ADDENDUM NO. 3
DTCC OFFICE OF THE PRESIDENT
BID PACKAGE B
Dover, Delaware 19904

March 14, 2013

The contract documents for the above referenced project, dated February 5, 2013 are amended as follows:

Partial Fire Alarm Plan - Room 157

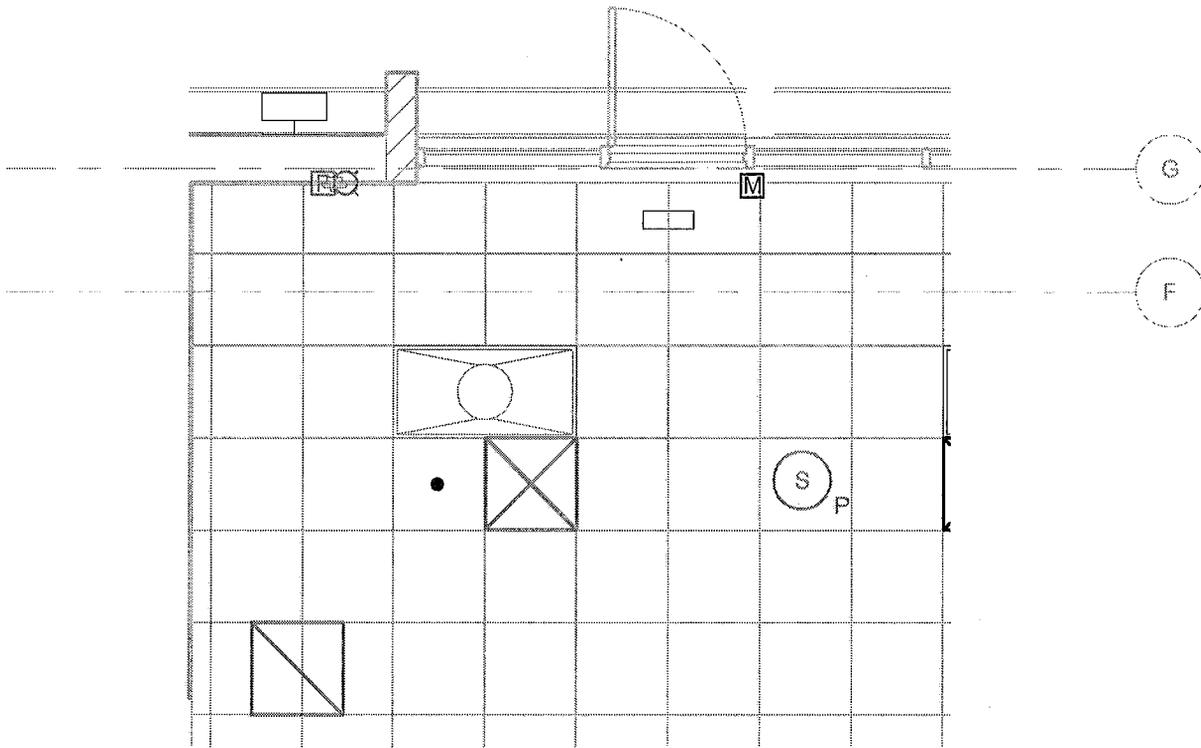
27	<p>E103; Administration Building Electrical System – 1st Floor Power Plan – New Work:</p> <ul style="list-style-type: none"> • ADD Sketches SKE 103-1 and SKE 103-2 MODIFYING the Fire Alarm System to the Sheet.
28	<p>E501; Electrical – Single Lone Diagrams & Lighting Fixture Schedule:</p> <ul style="list-style-type: none"> • New Work Notes; CHANGE “...and (1) 4” Spare Conduit” to read “...and two (2) Spare 4: Conduits.”
29	<p>E601; Schedules:</p> <ul style="list-style-type: none"> • Panel MDP; DELETE 30kva Transformer T-2 from Schedule and REPLACE with Spare. • CHANGE Transformer T-1 from 75kva to read 112.5kva”.
30	<p>E602; Schedules:</p> <ul style="list-style-type: none"> • Panel RP2: <ul style="list-style-type: none"> ○ PROVIDE 100 amp/3P Circuit Breaker in Panel RP2 in order to feed Panel LPB. ○ PROVIDE 20 amp/3P Circuit Breaker in Panel RP2 in order to feed the BWP-1

5 SINGLE EMERGENCY LOCK-DOWN ACCESS CONTROL DOOR DETAIL
Scale: NTS

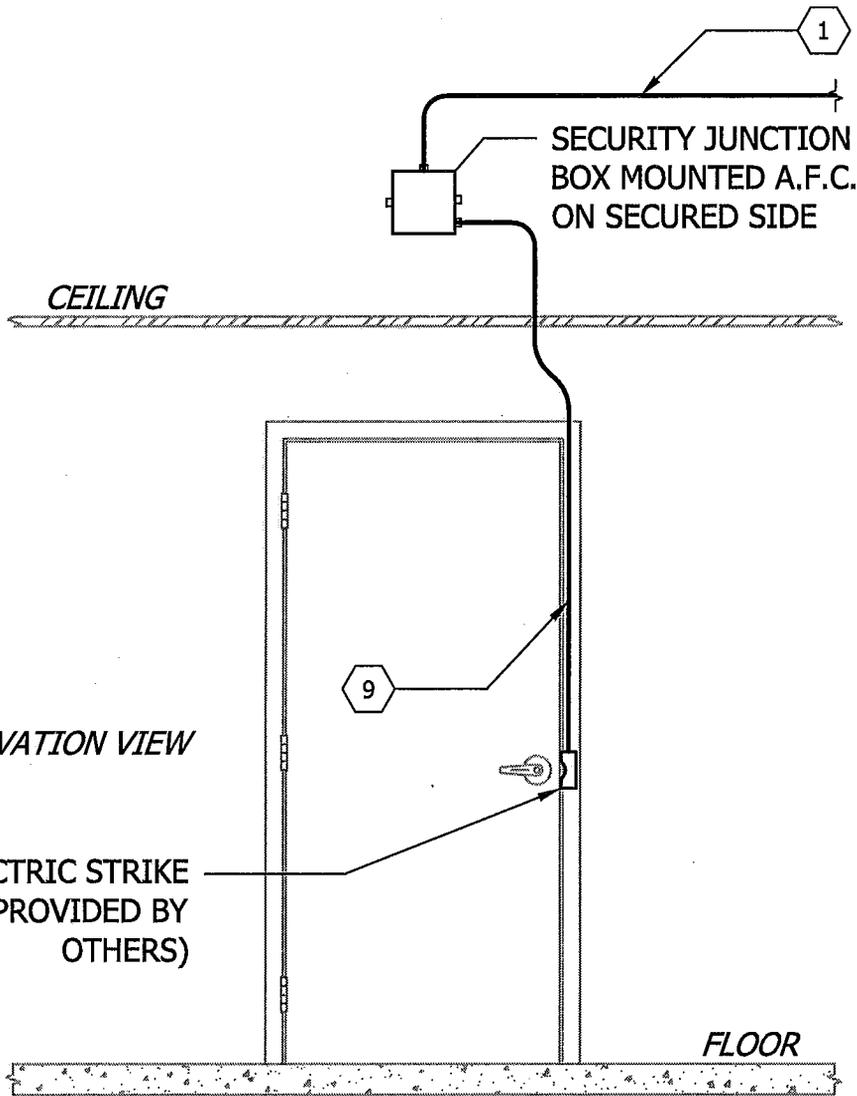
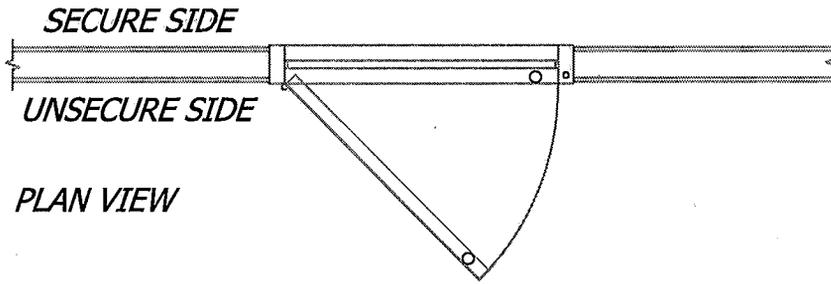
31	TA030; Telecom and Security Systems Typical Infrastructure Details: <ul style="list-style-type: none">• Add new Detail 5 as indicated in drawing SKTA-030-1, dated 03/14/13.• Add new Detail 6 as indicated in drawing SKTA-030-2, dated 03/14/13.
32	TA101; Telecom and Security Systems Floor Plan: <ul style="list-style-type: none">• Delete TA101 in its entirety, Substitute revised TA1-1, dated 03/14/13.
